Service Bulletin 69 Rev A

Subject: Seat Belt Anchor Points for Sportsman and Glastar Aircraft and Shoulder Harness Anchor Points for Glastar Aircraft

Applicability: All Glastar and Sportsman Aircraft

Figure 1

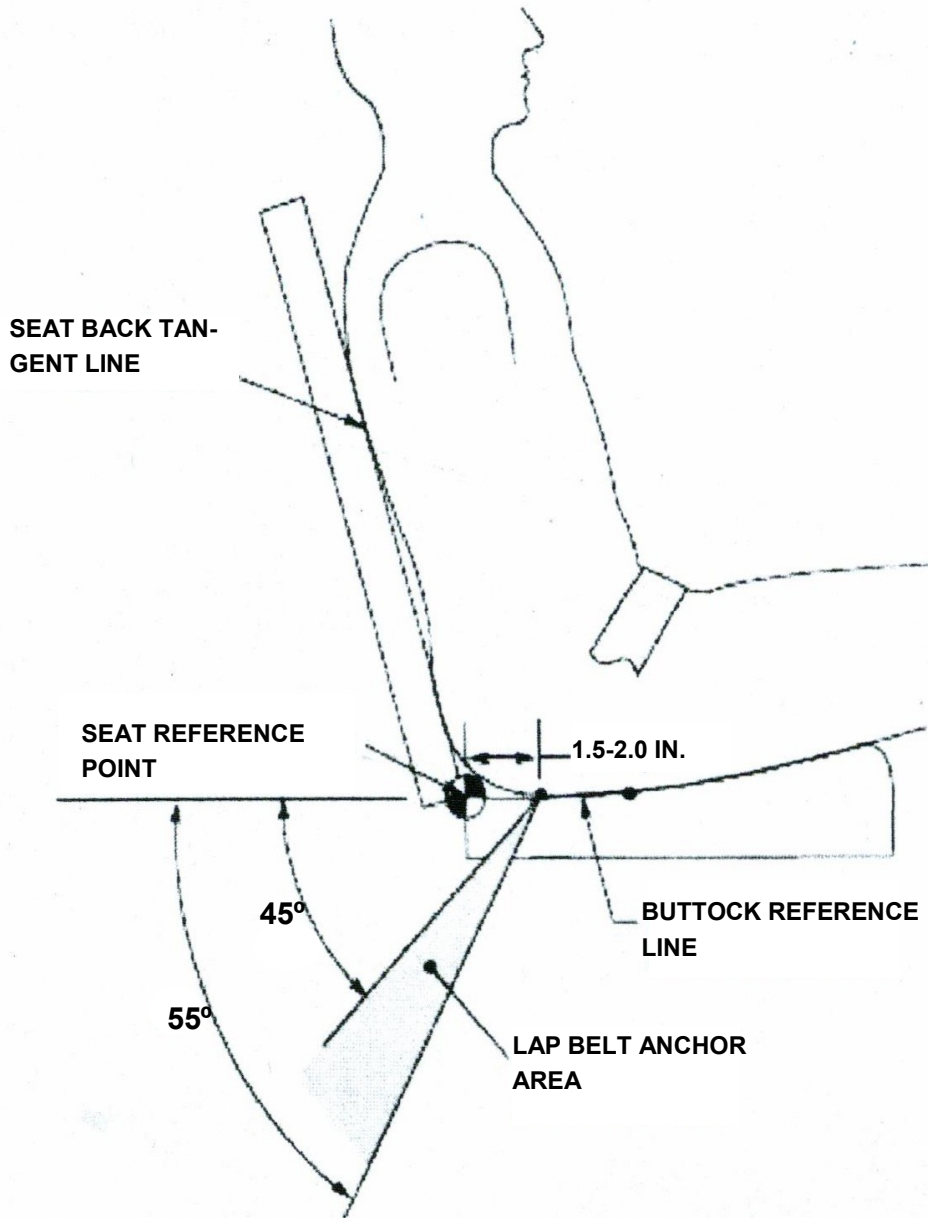
FAA Advisory Circular AC21-34 Shoulder Harness - Seat Belt Installations provides information and guidance for installation of shoulder harness and safety belt restraint systems. AC21-34 recommends that lap belt anchor points mount so as to maintain an angular range of 45° - 55° for all seat range positions. (See Figure 1 on page 2.) In addition, AC21-34 recommends that shoulder harness anchor points mount so as to maintain an angular range of -5° to +30° for all seat range positions. (See Figure 2 on the page 3.)

Figure 2

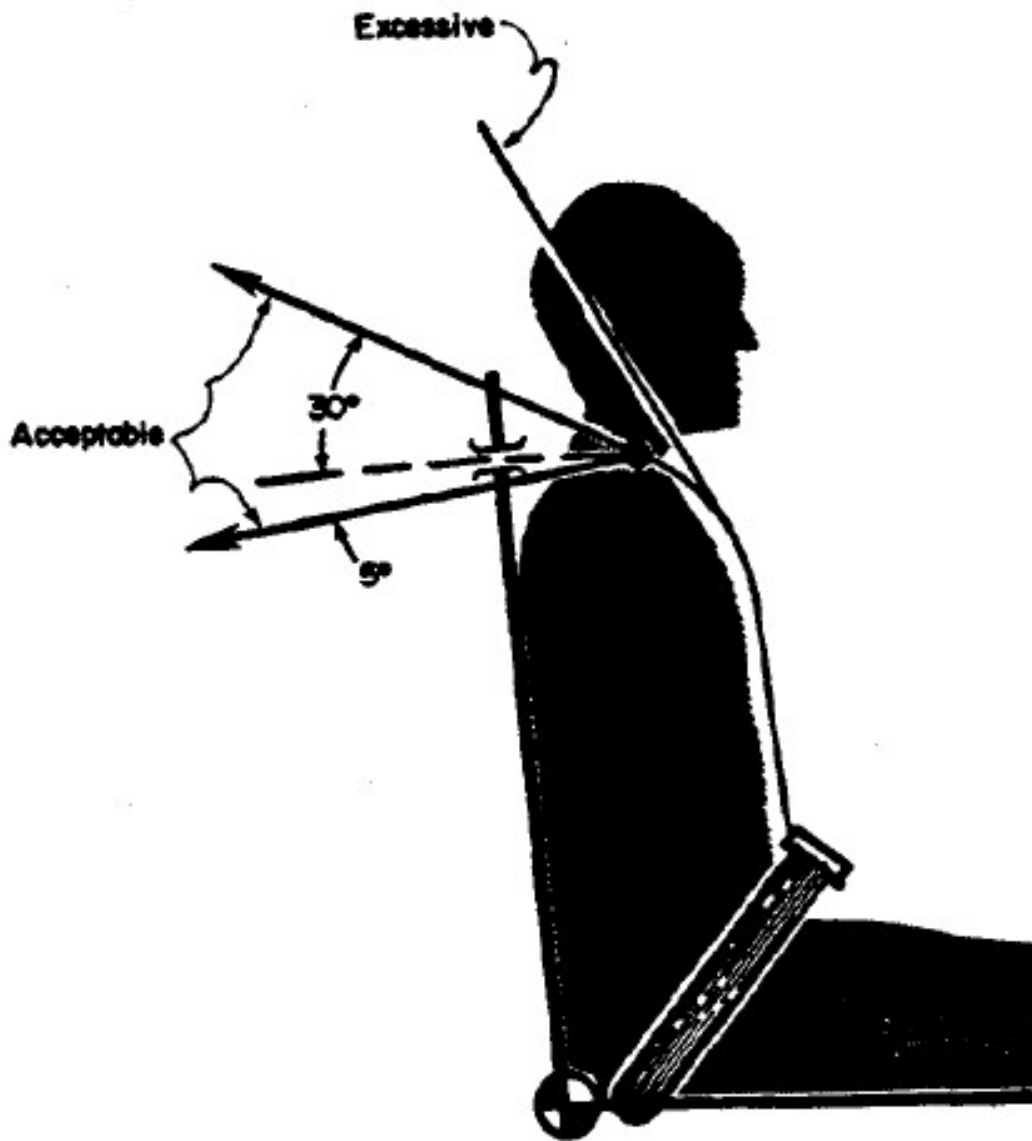
Since issuing SB69, it was discovered that Glastar shoulder harness upper attach points are not within the suggested angles of -5° to +30° of shoulder height. Thus, a shoulder harness cross bar retrofit kit (p/n 930-07300-201) was created to move these attach points to within the suggested range.
